Statement of Environmental Effects

Proposed Development | **Modification of DA 521/2017 –Mixed Use Development**

Property Address | **4 Lake Street, Forster NSW 2428**

25 August 2026

i. **Reconfiguration of floor plan to create 5 x Residential Units – Building C, Level 10**

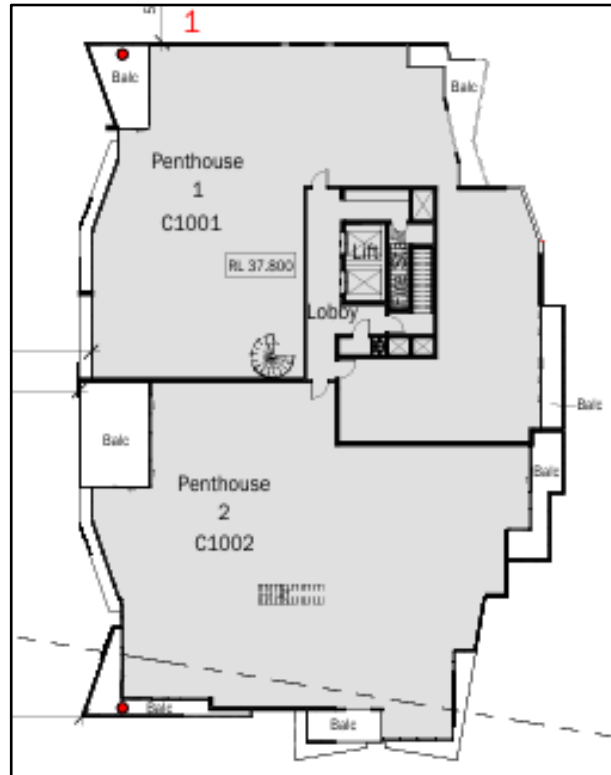
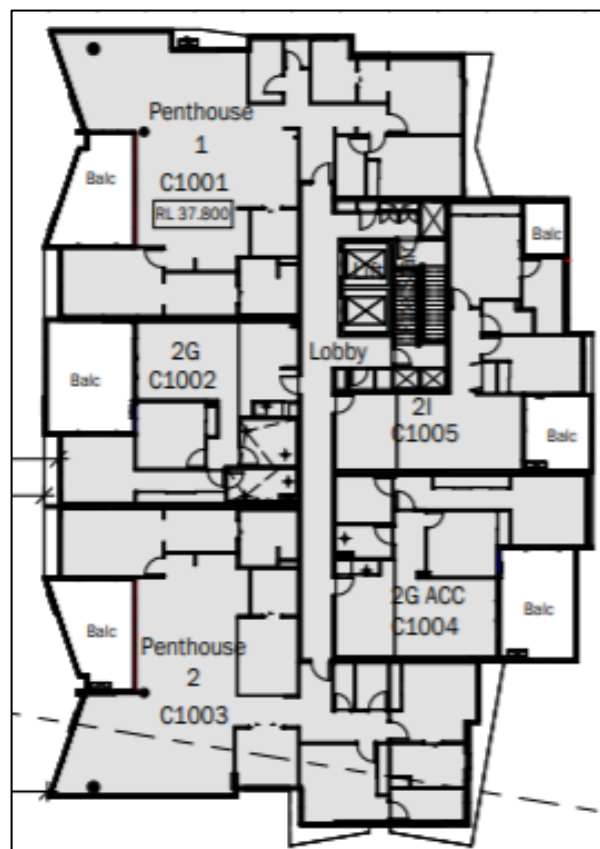
The approved development comprises two (2) penthouse units on Level 10 of Building C, including a private rooftop terrace associated with each unit. The proposed modification seeks to reconfigure the floor plan to replace the two (2) units with five (5) seniors living units. The proposed modified plans also remove the roof top terrace areas and amend the roof design of Building C.

Figures 3 and 4 below depict the existing approved floor plan and proposed modified floor plan for Level 10. The existing approved western elevation and proposed western elevation in Figures 5 and 6 below illustrate the variation to Building C's roof design.

As depicted in *Plan no. 5490.33 (9)- Level 10 Floor Plan, prepared by TVS Architects in Appendix A*, the proposed modification predominantly retains the same shape as the existing approved floor plate. The modified plans replicate the floor plates of Levels 4-9, with the exception of the removal of the south-western balcony (Unit C1003) and the north-western balcony (Unit C1001).

The modified floor plan will decrease the floor area of level 10 by 23.9m².

ii. Minor reconfiguration of floor plans for Typical Unit 2G and 2I – Building C, Levels 5-9

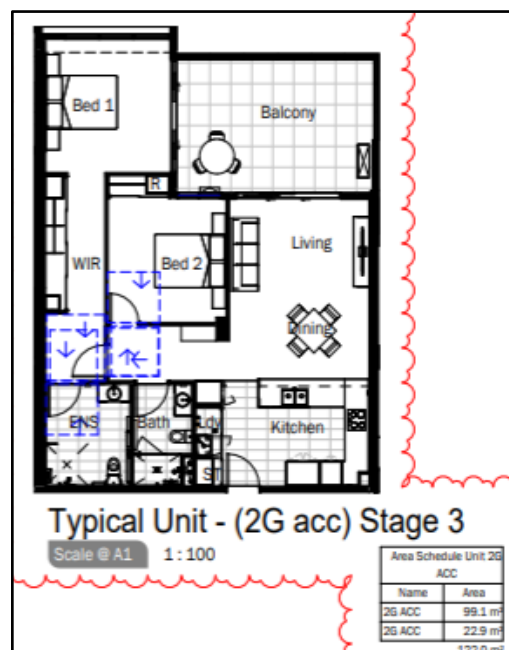
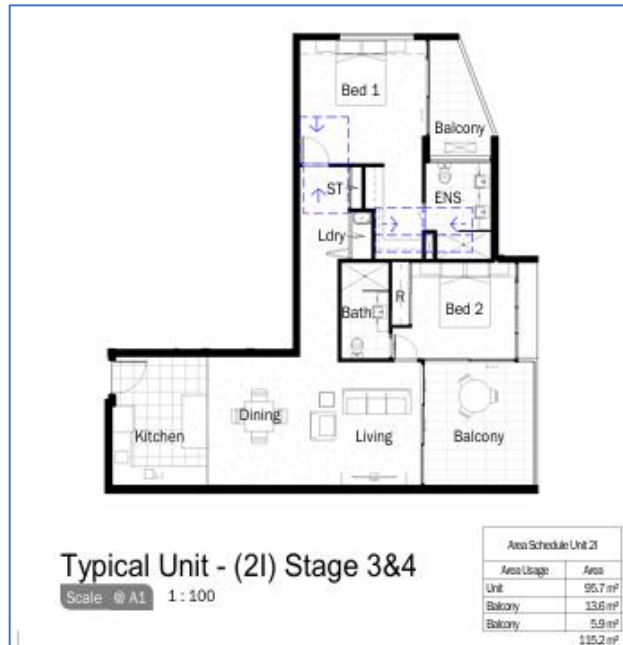
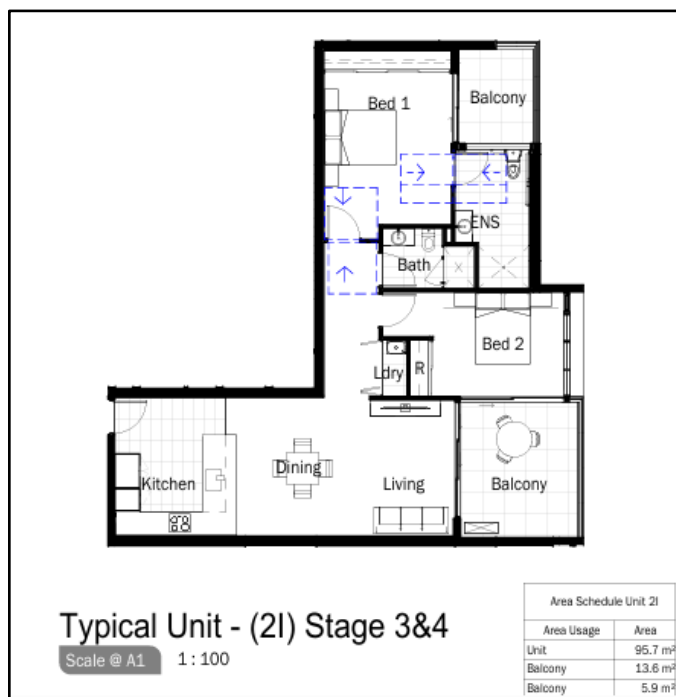
Typical Units 2G and 2I are located on the eastern elevation of Building C, Levels 5-9 and comprises a 2-bedroom seniors living residential apartment. As depicted in *Plan no. 5490.40 (9) – Typical Units Plan Stages 2,3 &4, prepared by TVS Architects* in **Appendix A**, the proposed modification seeks minor changes to the approved floor plan for Typical unit 2G and 2I. The modified floor plans seek to ensure these units comply with accessible design requirements where these units are included in Building C, Stage 3.

Figures 9 below depicts the proposed modified floor plan of Typical Units 2G for accessible units Building C, Stage 3. Figures 10 and 11 below depict the existing approved floor plans and proposed modified floor plans of Typical Units 2I. The most notable changes to the floors plan are the change to the balcony areas to remove the splay and provide better circulation space. The bedrooms, bathroom and ensuite of Typical Unit 2I have also been reconfigured to provide better use of space.

This modification will affect ten (10) units in total, being Unit C506, C507, C606, C607, C706, C707, C806, C807, C906, C907 & proposed units C1004 & C1005.

iii. Minor reconfiguration to residents dining room – Building C, Level 3

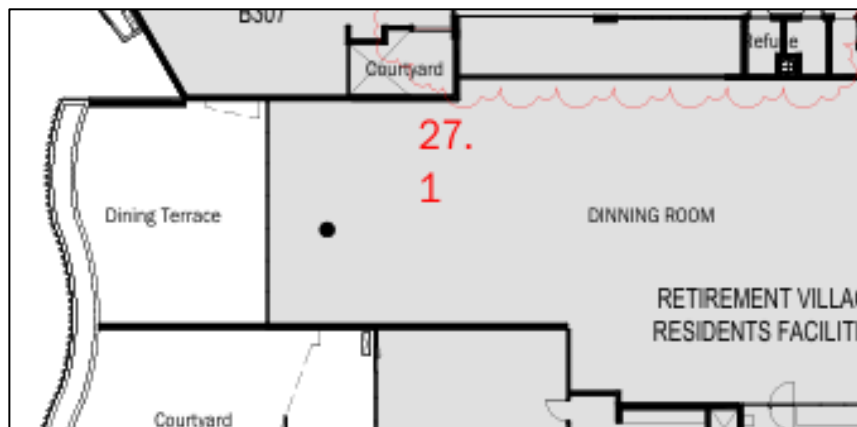
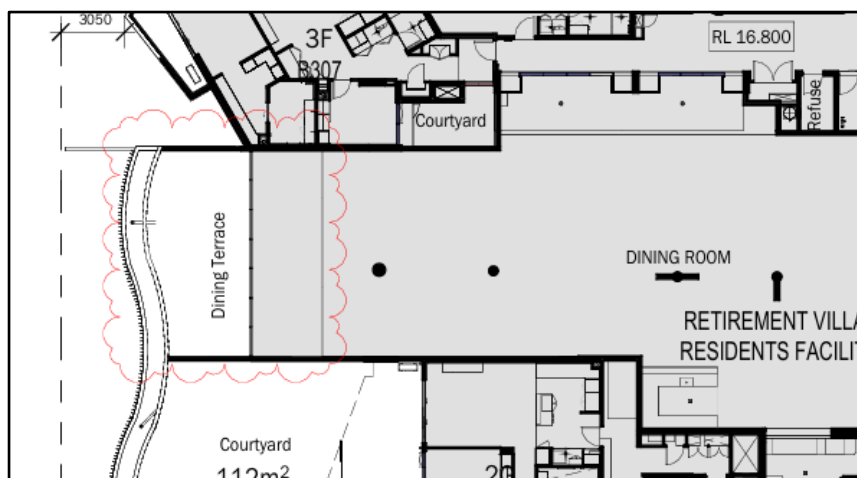
The approved development includes a residents dining on Level 3 in Building C. As depicted in *Plan no. 5490.27 (13) – Level 3, prepared by TVS Architects* in **Appendix A**, the proposed modification seeks to enclose part of the terrace associated with the residents dining room. Figures 12 and 13 below demonstrate the approved plan and proposed minor changes to the residents dining room.

Given the development is intended to support an older demographic, residents typically make limited use of outdoor communal areas, with enclosed communal spaces being preferred. Enclosing the verandah will provide better use of the space whilst retaining a consistent visual appearance to adjacent areas of the development.

The modified design will include a small extension to the roof over the new enclosed area and will retain the planter box along the edge of the verandah. The modified floor plan will increase the floor area of the residential dining area and overall gross floor area of the development by 34m². The proposed modifications will not adversely affect the visual characterises of the building's façade of this part of the building.

iv. Reconfiguration to Residents communal external area – Level 3 between Buildings C & D

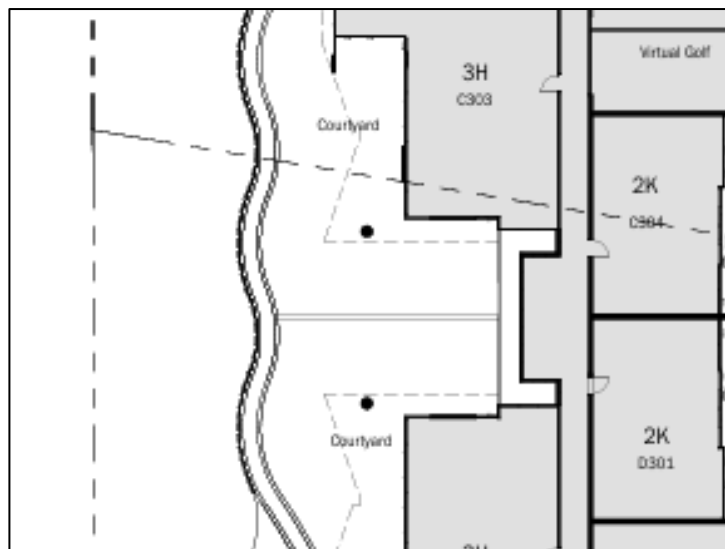
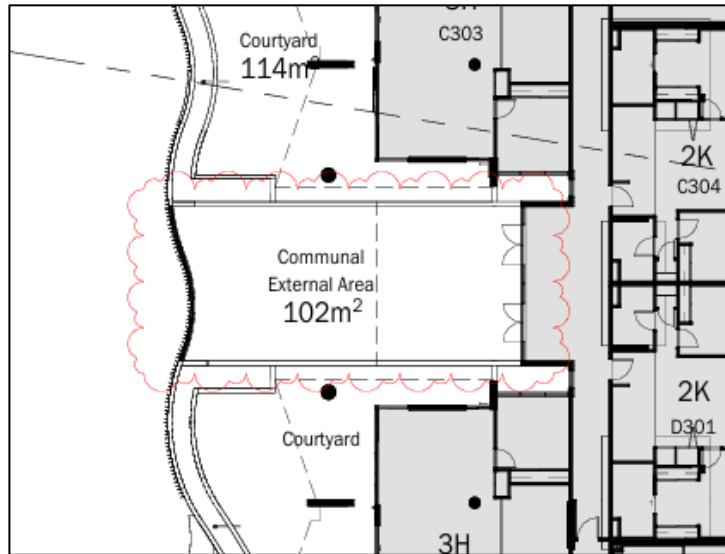
The approved development includes a courtyard space on Level 3 on the western side of the development between Buildings C and D. As depicted in *Plan no. 5490.27 (13)- Level 3 Floor Plan, prepared by TVS Architects* in **Appendix A**, the proposed modification seeks to formalise and delineate this area to create a communal external space for residents to enjoy. Figures 14 and 15 below demonstrate the approved plan and proposed changes to the communal external area between Buildings C & D on Level 3.

The proposed modification to this area includes a roof over part of the area with new access doors opening onto the space from a communal corridor. The modified floor plan will include a new glass balustrade feature along the edge of the terrace allowing for casual surveillance and interaction by residents with the street below.

The proposed modifications to this space will not increase the internal floor area of the building and will not adversely affect the visual characterises of the building's façade of this part of the building.

Figure 16 – Approved and Proposed Floor Plan Typical Unit 3H Level 3

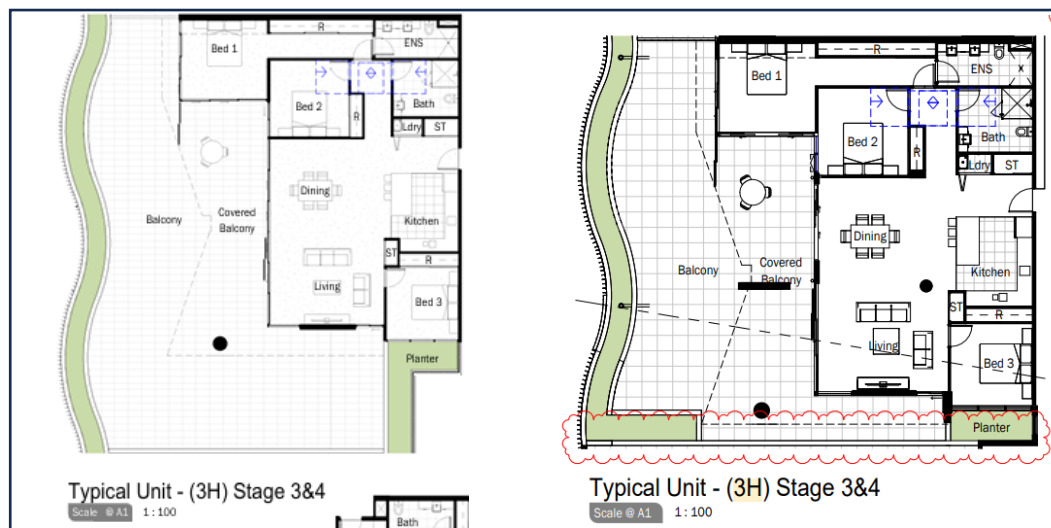
As a result of the proposed changes to create this communal area, the adjacent courtyards and planter boxes associated with Typical Units 3H will require configuration. Figure 16 below demonstrates the approved plan and proposed changes to the Typical Units 3H adjacent to the communal external area on Level 3. The modified plans will result in a minor decrease in private courtyard space for Unit 3H of 38m².
